CONNECTION ASSESSMENT & APPROVAL PROCESS

*Project: Porcupine TS:
500kV & 115kV Switchyards:
Replace the existing Air-blast Circuit Breakers with SF₆ Units*

CAA ID No. 2004-EX204

*Date: 12th October 2004
Revised: 23rd February 2005*

Proposed 'Physical' Arrangement of the 500kV Switchyard at Porcupine TS

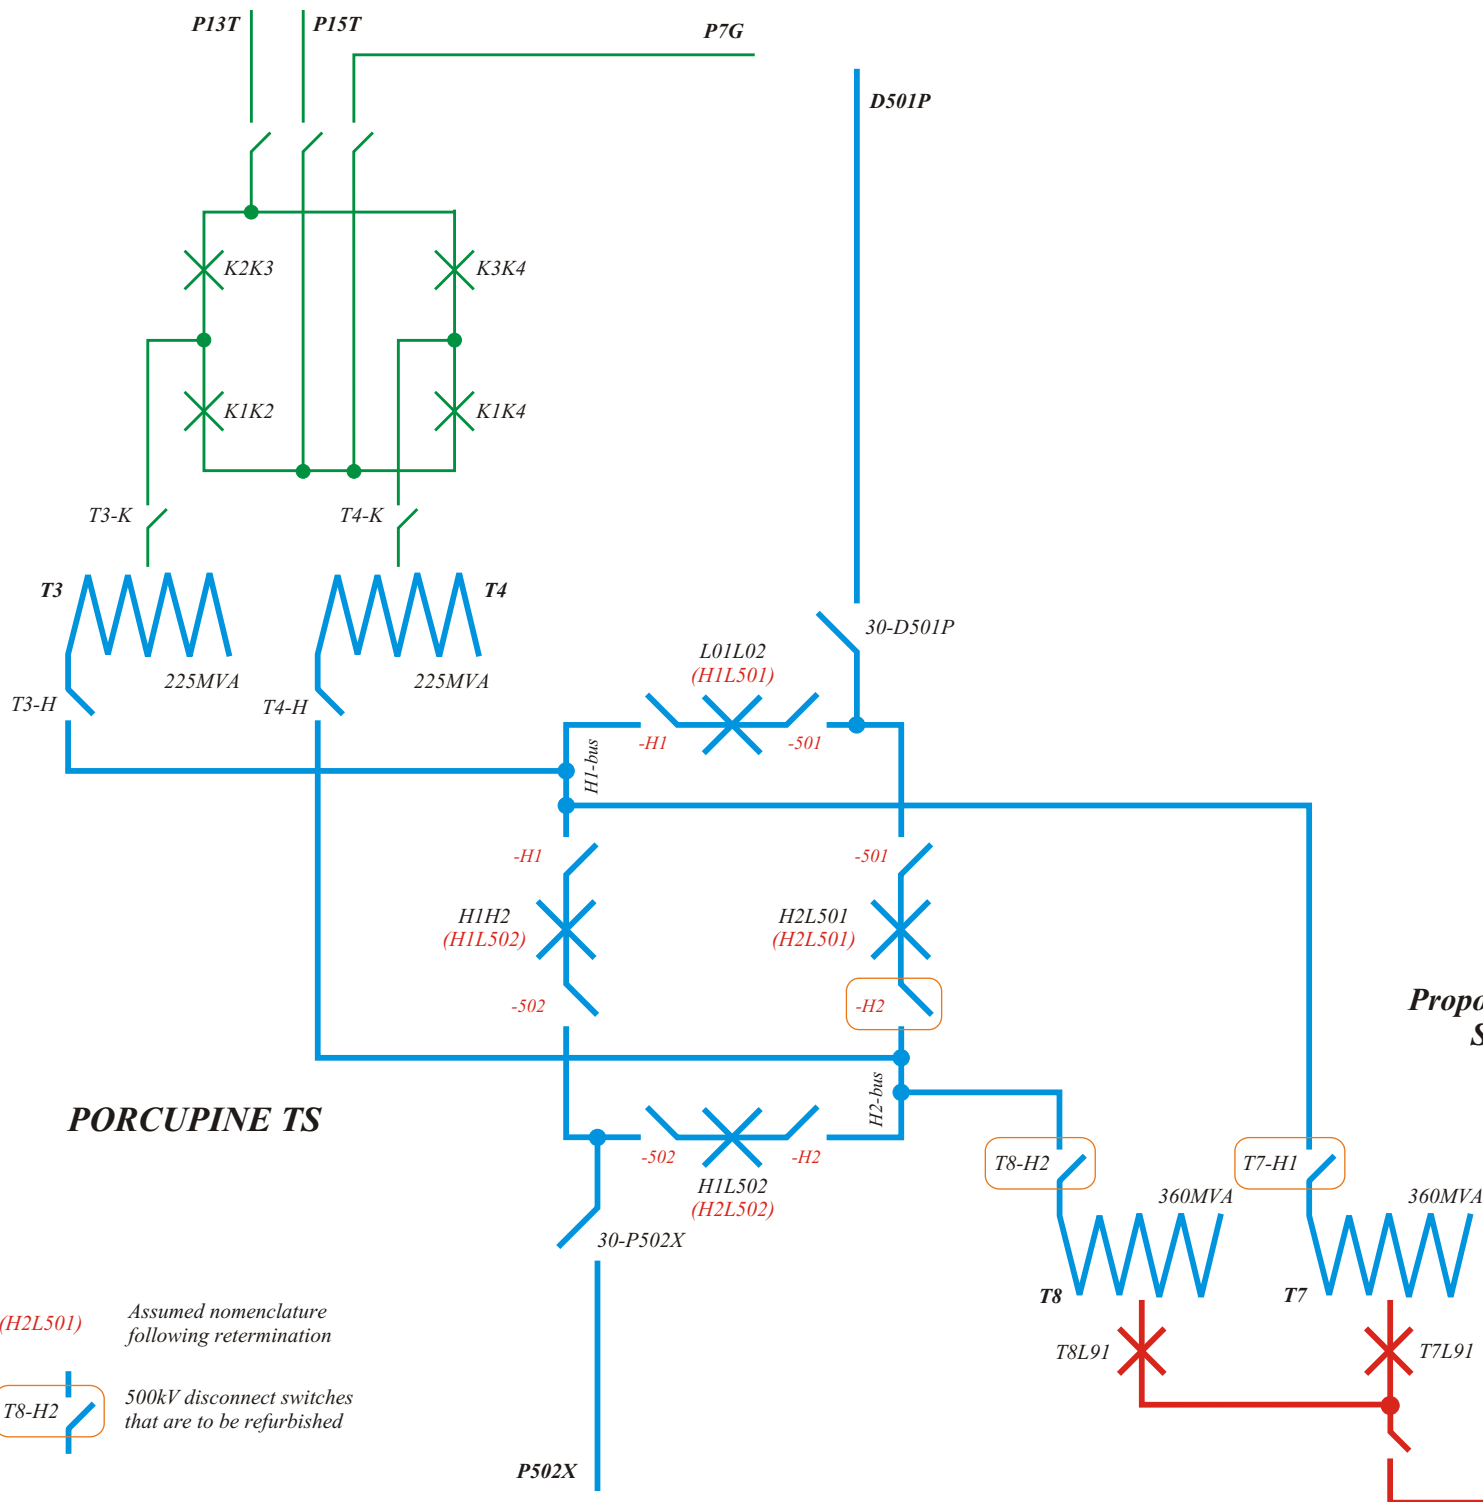
Diagram 3 shows the final arrangement of the 500kV switchyard once the fourth breaker has been installed and the existing breakers have been replaced. The corresponding Single-Line Diagram of the revised connection arrangement is shown in Diagram 4.

This would result in the terminations of the 500kV circuits alternating with those of the auto-transformers, around the ring busbar, thereby eliminating the risk with the present arrangement of losing both 500kV circuits due to a malfunction of the common 500kV ABCB L01L02.
